Title: **CR's to TS 34.123-3 v3.0.0 for approval**

This document contains 15 CRs to TS 34.123-3 v3.0.0. These CRs have been agreed by T1 and are put forward to TSG T for approval.

Title:	⌘	CR for inclusion of test case 9.2.3 to NAS ATS V3.0.0
Source:	⌘	Rohde & Schwarz/ Anritsu/ MCC160
Work item code:	⌘	N/A
Date:	⌘	10 Feb 2003
Category:	⌘	**F**
Release:	⌘	R99

4.19 Superfluous information elements in RRC_RB_Setup (WA #RLC 3025)

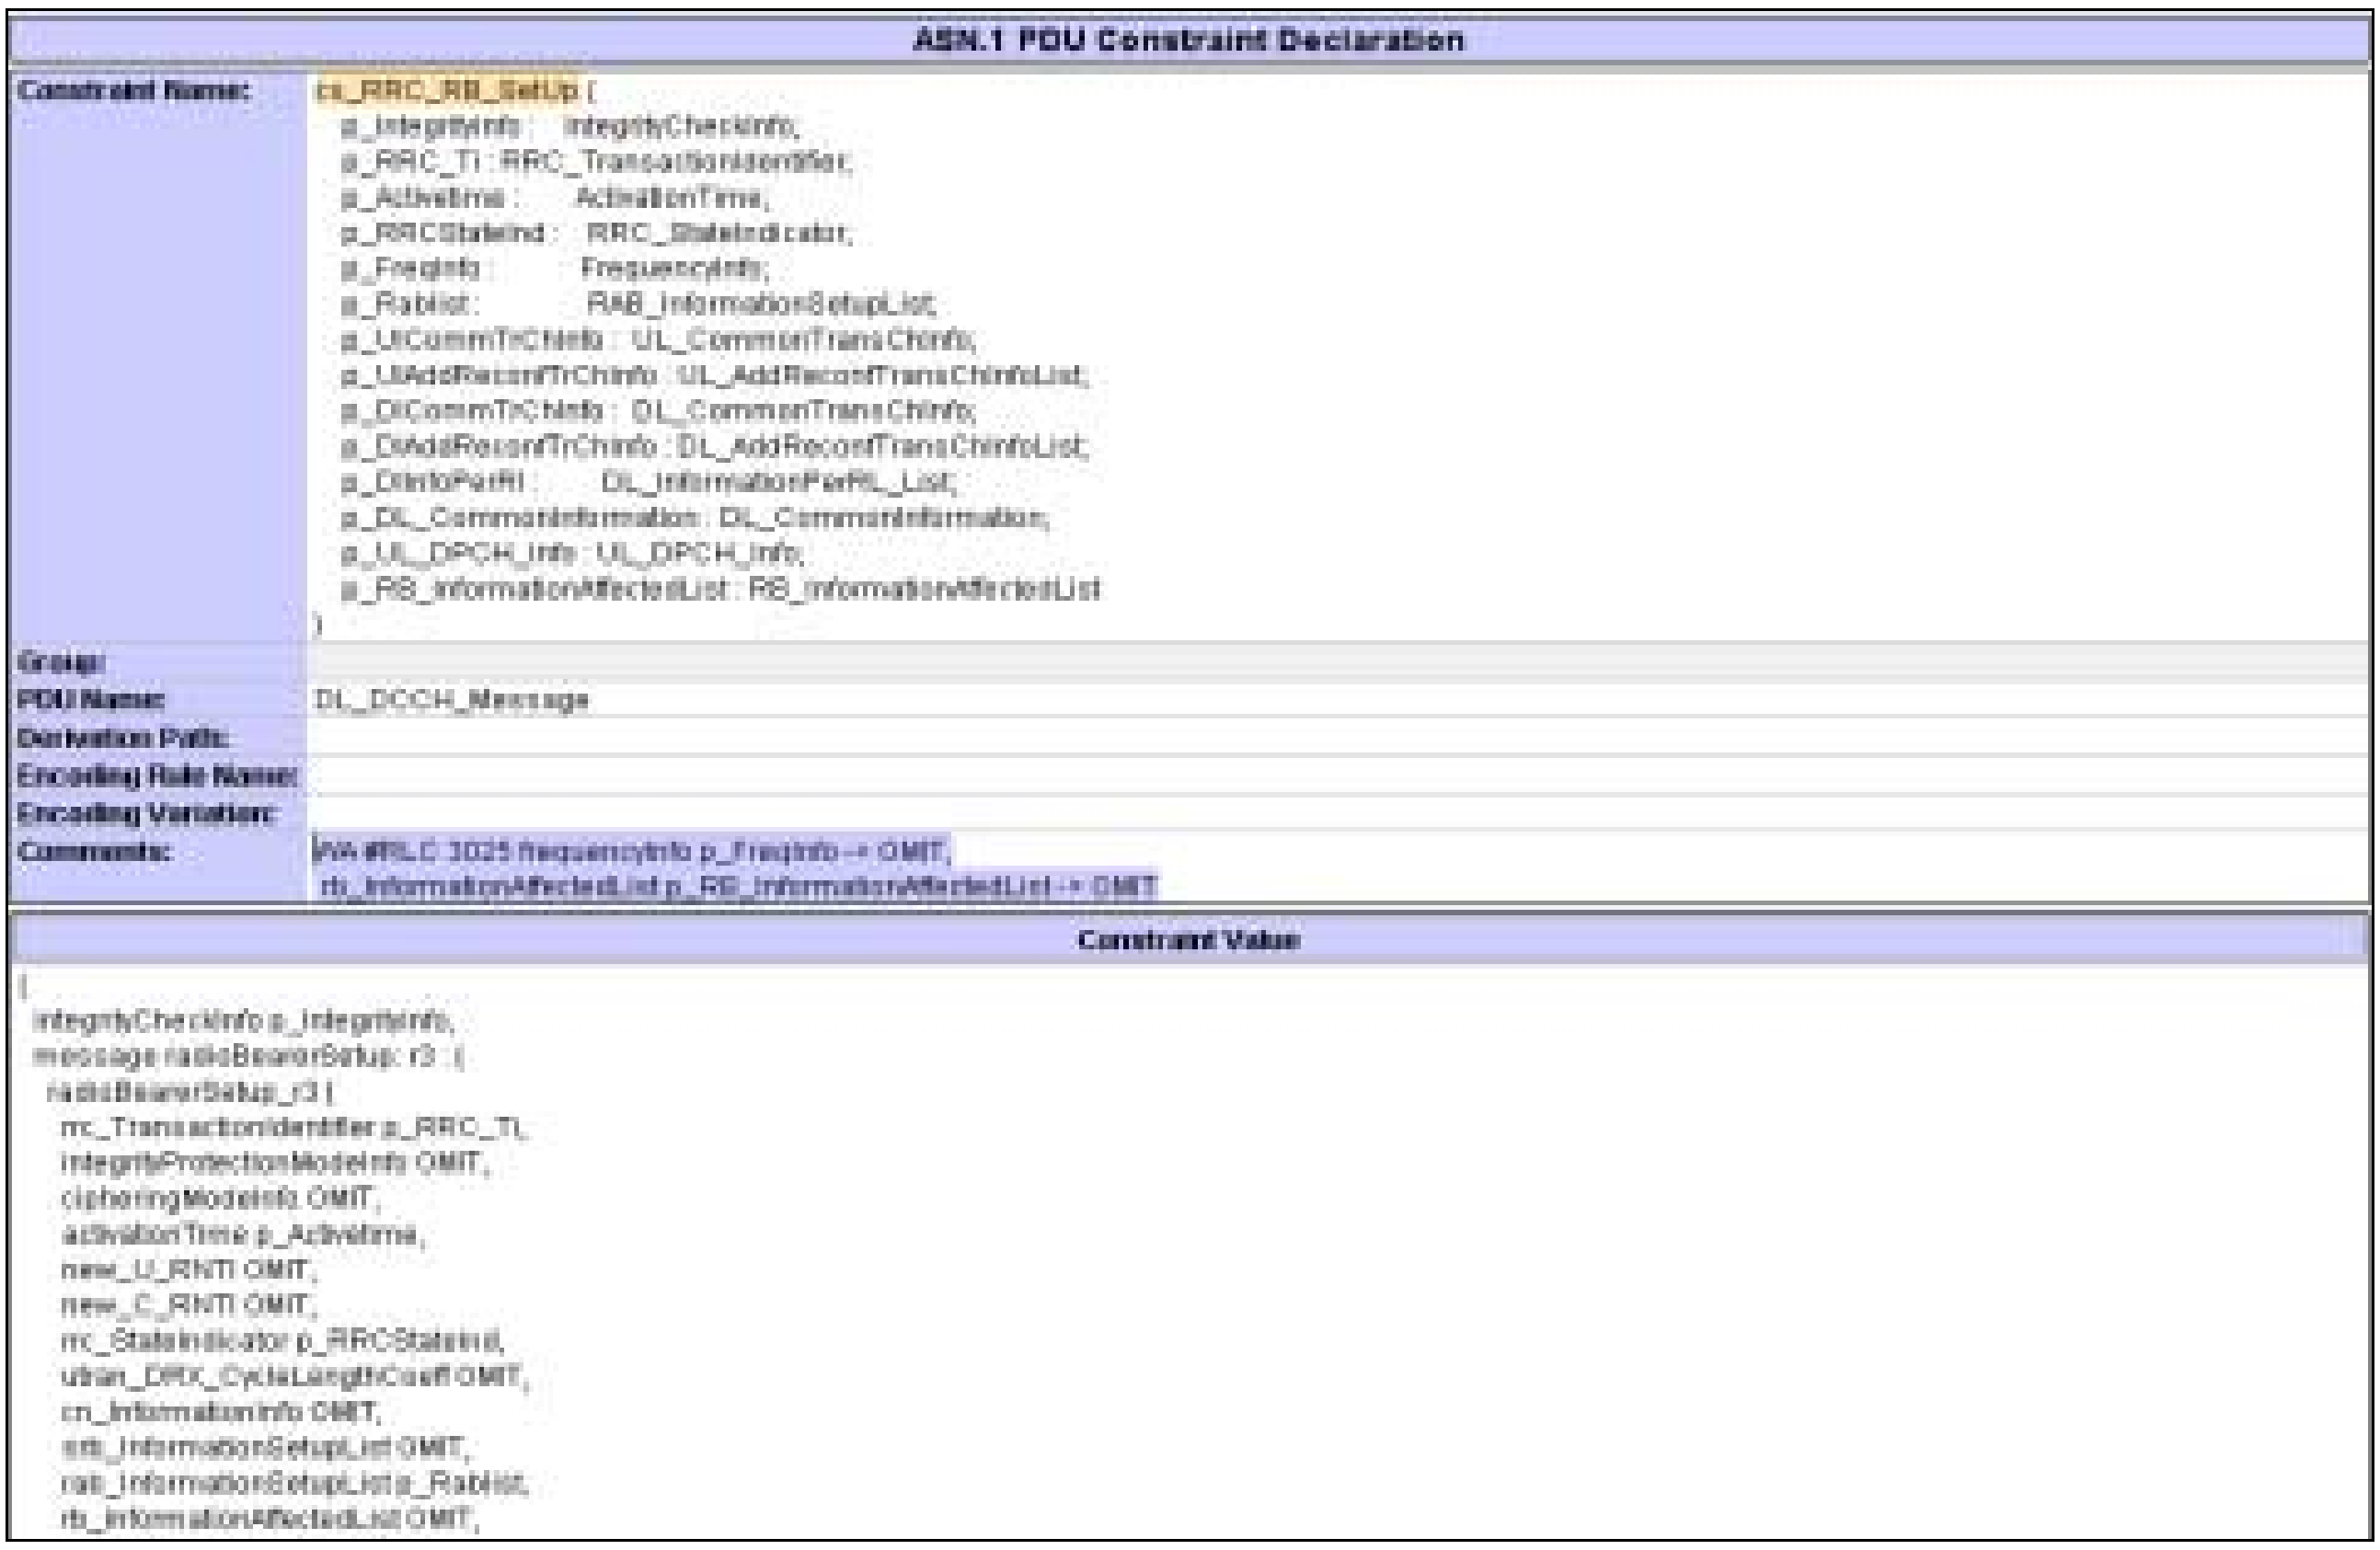
Constraint name	cs_RRC_RB_SetUp
Reason for change	Information elements FrequencyInfo and rb_informationAffectedtList in the radio bearer setup message are regarded as superfluous. UEs do not work with these elements exist in the message.
Summary of change	frequencyInfo p_FreqInfo is OMITted, rb_InformationAffectedList p_RB_InformationAffectedList is OMITted.
Source of change	new change
Label	WA #RLC 3025

ASN.1 PDU Constraint Declaration	
Constraint Name:	cs_RRC_RB_SetUp (p_IntegrityInfo : IntegrityCheckInfo; p_RRC_TI : RRC_TransactionIdentifier; p_Activetime : ActivationTime; p_RRCStateInd : RRC_StateIndicator; p_FreqInfo : FrequencyInfo; p_Rablist : RAB_InformationSetupList; p_UlCommTrChInfo : UL_CommonTransChInfo; p_UlAddReconfTrChInfo : UL_AddReconfTransChInfoList; p_DlCommTrChInfo : DL_CommonTransChInfo; p_DlAddReconfTrChInfo : DL_AddReconfTransChInfoList; p_DlInfoPerRl : DL_InformationPerRL_List; p_DL_CommonInformation : DL_CommonInformation; p_UL_DPCH_Info : UL_DPCH_Info; p_RB_InformationAffectedList : RB_InformationAffectedList)
Group:	
PDU Name:	DL_DCCH_Message
Derivation Path:	
Encoding Rule Name:	
Encoding Variation:	
Comments:	WA #RLC 3025 frequencyInfo p_FreqInfo -> OMIT, rb_InformationAffectedList p_RB_InformationAffectedList -> OMIT

4.20 Paging problems with TMSI (WA #RLC 3027)

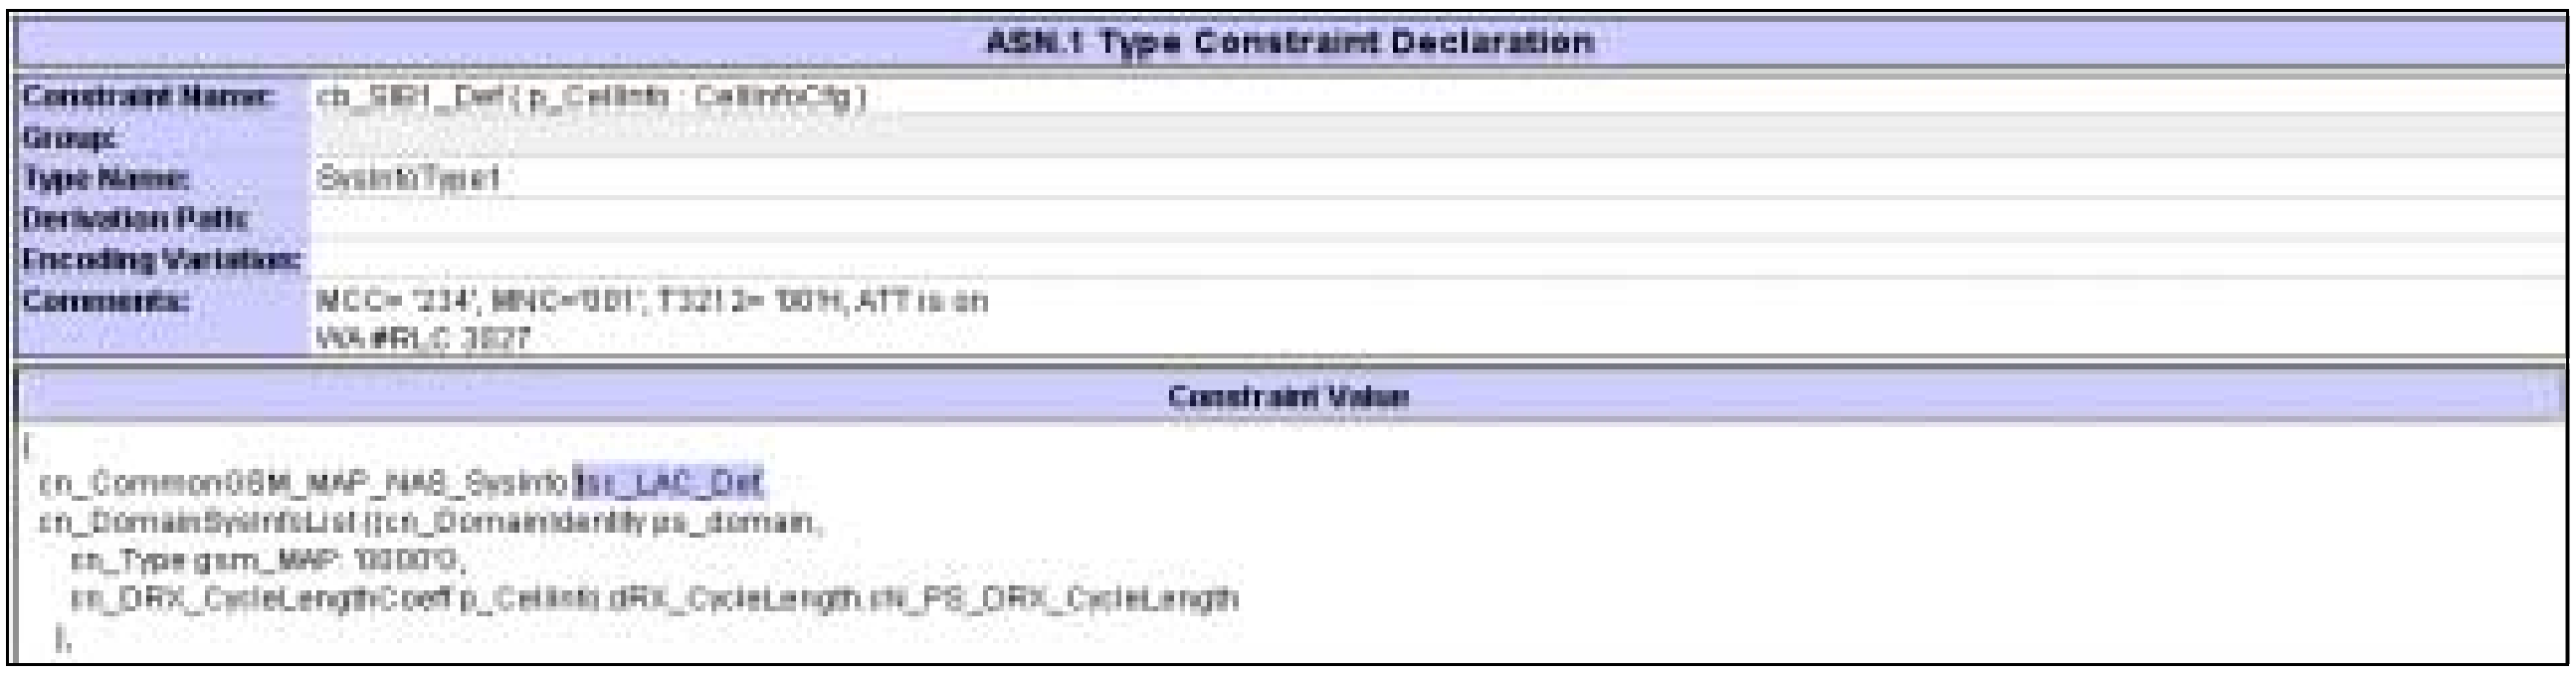
Constraint name	cb_SIB1_Def
Reason for change	cb_SIB1_Def, tsc_LAC_Def take inconsistent values so paging with TMSI fails.
Summary of change	cb_SIB1_Def takes tsc_LAC_Def instead of ‘0080’O and tsc_LAC_Def is modified from ‘0001’O to ‘0080’O
Source of change	approved ATS V1.43
Label	WA #RLC 3027

ASN.1 Type Constraint Declaration	
Constraint Name:	cb_SIB1_Def (p_CellInfo : CellInfoCfg)
Group:	
Type Name:	SysInfoType1
Derivation Path:	
Encoding Variation:	
Comments:	MCC= '234', MNC='001', T3212= '00'H, ATT is on WA #RLC 3027
